## ***MAJOR PROJECT ASSESSMENT St Vincent's Research Precinct, Darlinghurst***

***MP 09\_0010 (Concept Plan)***

Director General's Environmental  
Assessment Report  
Section 75I of the  
Environmental Planning and Assessment  
Act 1979

**Figure 11:** Exhibited Building Heights – East Elevation

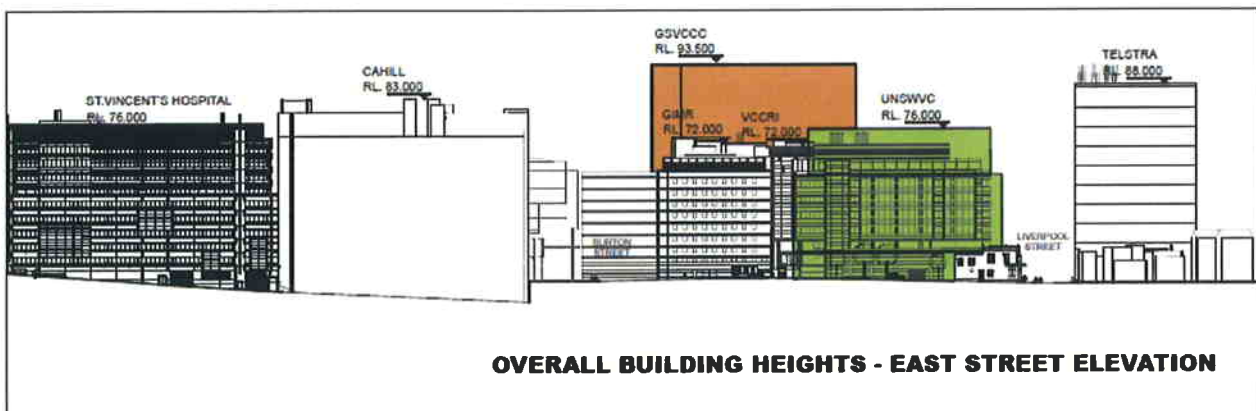
The exhibited Concept Plan proposal consisted of a 9 storey building envelope for the Stage 2 site - to a maximum height of RL 76, as illustrated in **Figure 11**. The proposed height and scale was identified as an issue by the Department, Council and residents as it resulted in an envelope that was considered to be excessive given the interface with the residential development immediately to the east.

**Figure 12:** Amended Building Heights (PPR) – East Elevation

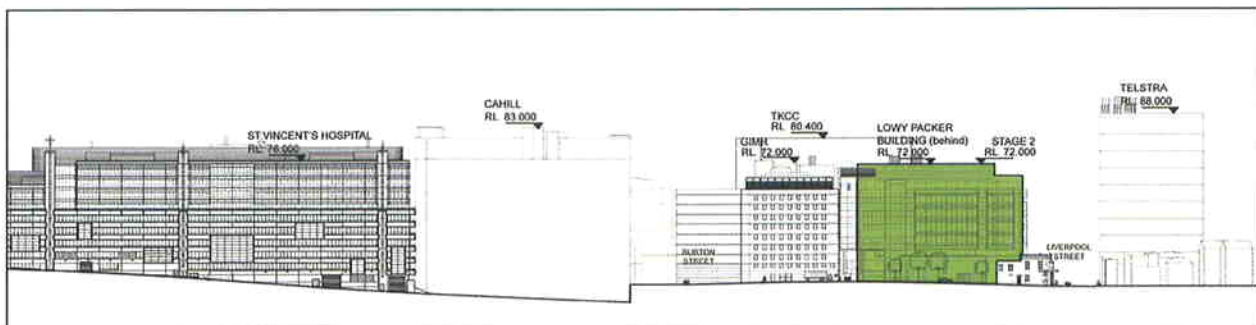
Following discussions between officers of the Department and the Proponent regarding the scale of the proposal, the height of the Stage 2 building envelope was reduced in the PPR by approximately 1 storey or 4 metres, and is now identical in height to the adjoining Lowy Packer building (RL 72), as illustrated in **Figure 12**.

The proposed height and scale of Stage 2 as proposed in the PPR was still identified as an issue by Council and local residents. Submissions have pointed to the inconsistency of the proposal with the height for the site identified in the *2005 Masterplan*. The Masterplan identifies

The Department therefore considers that the reduced height of the Stage 2 building envelope to RL 72 is acceptable in terms of its compatibility with the scale of surrounding development, and is considered to be consistent with the provisions of the SSDCP. In this regard, the Department considers the proposed departure from the 2005 Masterplan to be acceptable. The Department considers the height of the proposal would not result in any detrimental visual impacts when viewed from a distance given the heights of buildings within the Precinct and location within the Precinct, and its proximity to other buildings of similar height and scale. Furthermore, no additional obstructions or significant view loss is expected from the Darlinghurst Primary School given its location and the existing built form within the Precinct.

Accordingly, the Department considers the height of Stage 2 site is acceptable provided setbacks of the upper levels are provided on the eastern boundary to address the Precinct interface with the low-scale residential development located immediately to the east of the site. The Department has recommended that setbacks of a minimum 2 metres and up to 10 metres on the plant level be applied to the eastern boundary.

**Figure 13:** Amended Stage 2 Building Envelope (PPR)

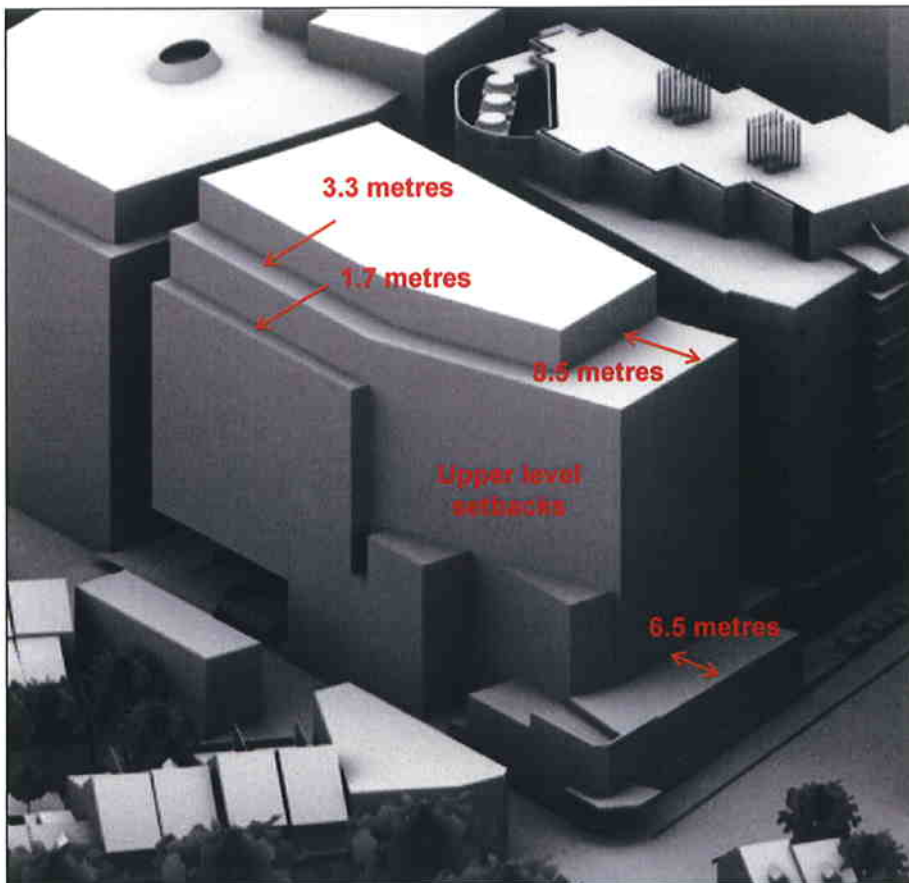
In response to issues raised, the proponent revised the proposed building envelope for Stage 2 by reducing it by one storey (4 metres) and introducing setbacks on the upper levels to West and Liverpool Streets, including provision of a podium element. The proponent has indicated that the depth of the southern proportion of the building is required for laboratory floor space and aligns with the GIMR building and therefore has not been setback.

The northern podium element is equivalent to two levels and is setback approximately 6.5 metres to Liverpool Street, which results in the tower element aligning with the VCCRI façade. The plant level has also been setback by 15 metres to Liverpool Street. Minor setbacks and articulation of the eastern building envelope have also been provided to West Street, including setback of the plant level by 3.3 metres, setback of the uppermost habitable floor by 5 metres

and setback of the upper levels of the corner section adjacent to 431 Liverpool Street (see **Figure 13**).

The revised building envelope would provide an improved built form relationship with the adjoining buildings, particularly the VCCRI and 431 Liverpool Street. However, given that the Stage 2 building forms the eastern edge of the Precinct that is adjacent to the low-scale residential areas immediately to the east, the Department considers there should be further reductions in the bulk and scale to provide an improved transition between the building forms of the Precinct and the residential development immediately to the east (including 431 Liverpool Street), which will improve the interface with the surrounding residential development and reduce potential impacts on residential amenity.

**Figure 14:** Indicative recommended modifications to Stage 2 Building Envelope

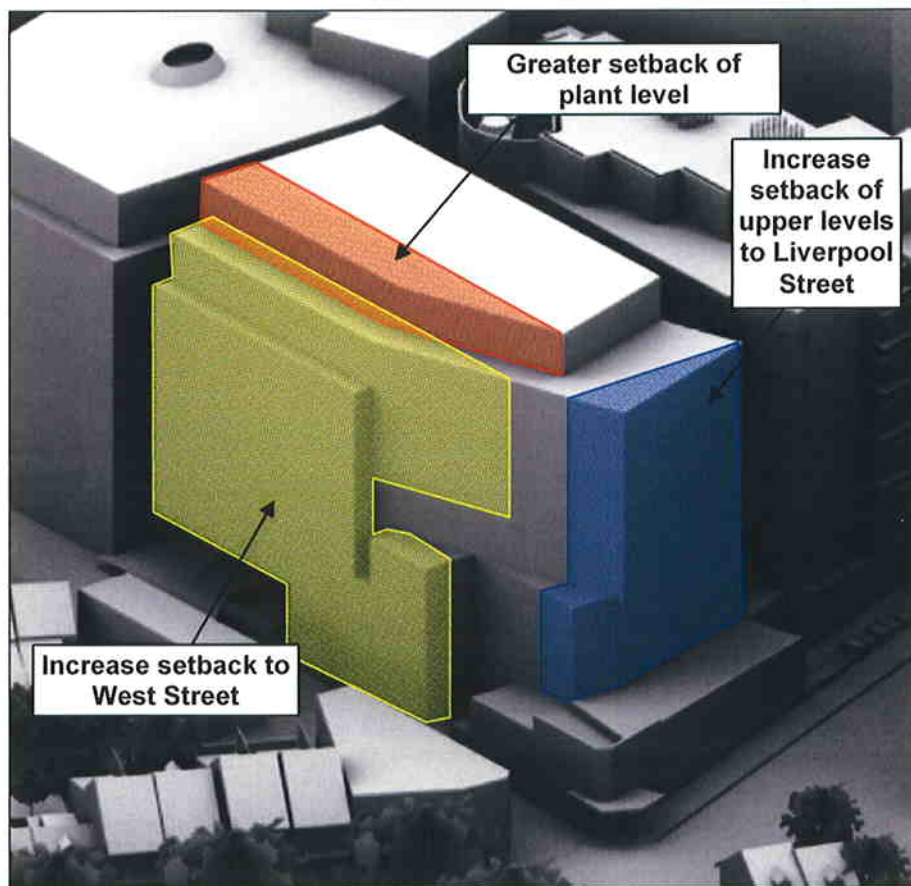
The Department has therefore recommended design modifications to the building envelope (see **Figure 14**) along Liverpool Street and West Street. This includes increased setbacks to Liverpool Street to reduce the bulk and scale of the building from the east and improve the interface with 431 Liverpool Street, while maintaining its relationship with the form of the VCCRI. The recommended modification will require the Proponent to provide a revised building envelope that:

- provides a minimum 15 metre setback of the plant level (Level 9) from the Liverpool Street boundary, to reduce the bulk and scale of the building from the east.

- a minimum setback of 2 metres from the West Street boundary for Levels 2 to 5, which would allow a landscape zone to be provided and reduce the appearance of a solid wall;
- a minimum setback of 5.5 metres from the West Street boundary for Levels 6 to 8, which would reduce the bulk and scale of the building envelope; and
- a minimum setback of 10 metres from the West Street boundary for Level 9 (plant), to further minimise the bulk and scale of the Stage 2 building envelope.

**Figure 18:** New Loading Dock

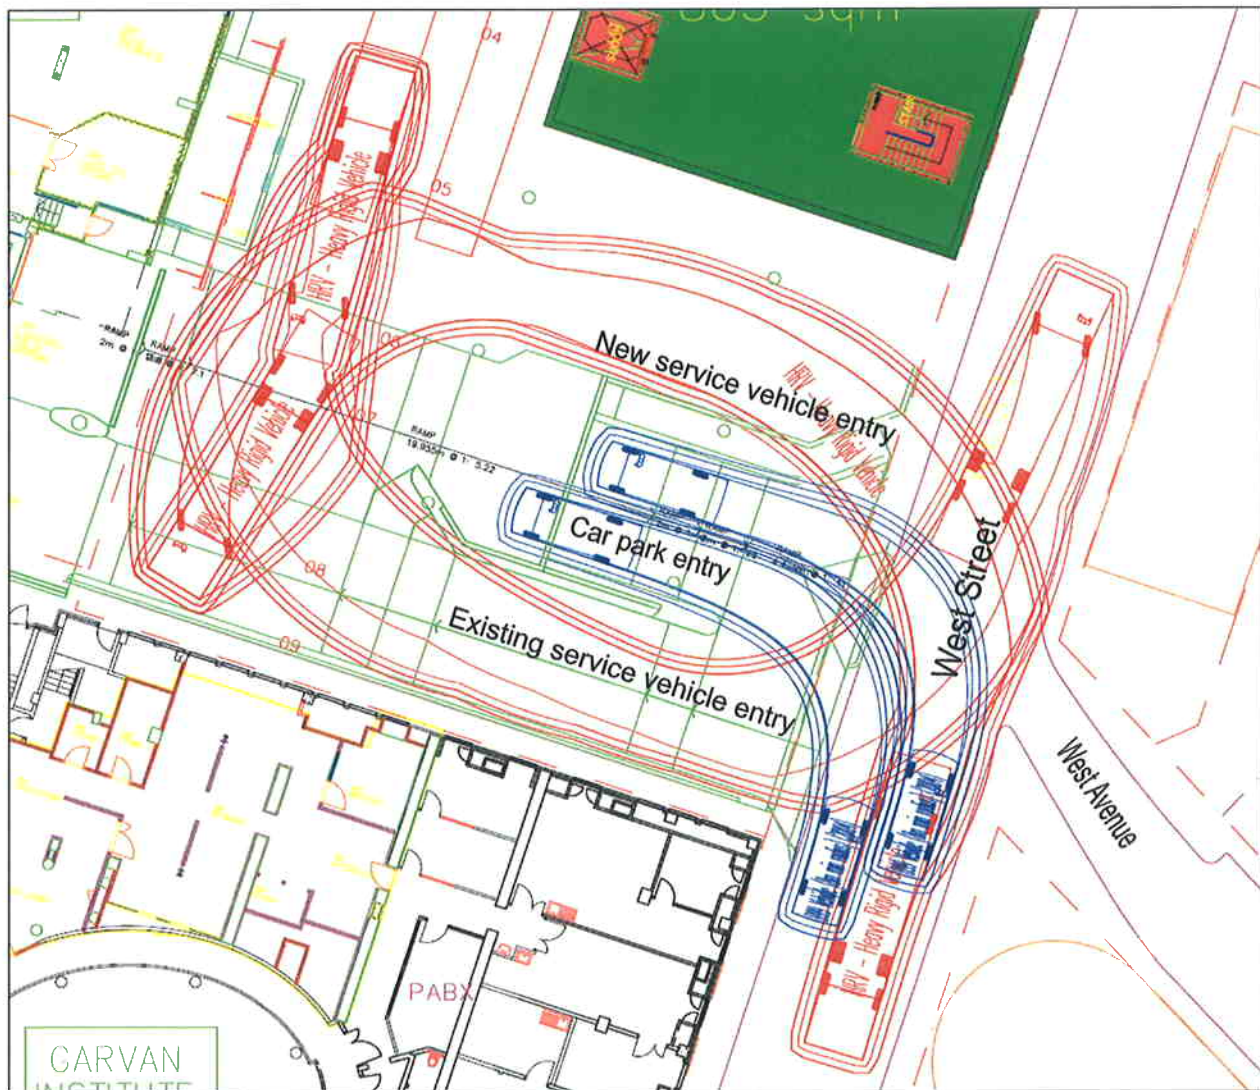
Some HRVs currently reverse into the loading dock from West Street. This situation can be tolerated with the existing very low traffic volumes in West Street. However, as a consequence of the KCC and Stage 2 developments it will be necessary to ensure HRVs enter and exit in a forward direction. This is proposed by providing separate entry and exit driveways.

A number of designs have been considered by the Proponent and an entry driveway on the northern side of the existing basement car park entry is proposed. The existing two-way driveway to the loading dock is proposed to become an exit only driveway. In terms of the number of bays, one additional truck bay suitable for an HRV and two additional spaces for vans/cars are proposed to cater for the proposed development. The operating of the loading dock is demonstrated in **Figure 18**.

Concern by residents that the new loading dock access will counteract the traffic measures required to limit traffic movement from West Avenue onto West Street was also considered in the Department's independent review of the traffic report. The review found that the new access is unlikely to result in additional impacts on West Avenue given the adequate deterrents of a 2 tonne limit for vehicles, uphill gradient, deflection to the right caused by the kerb blister, and
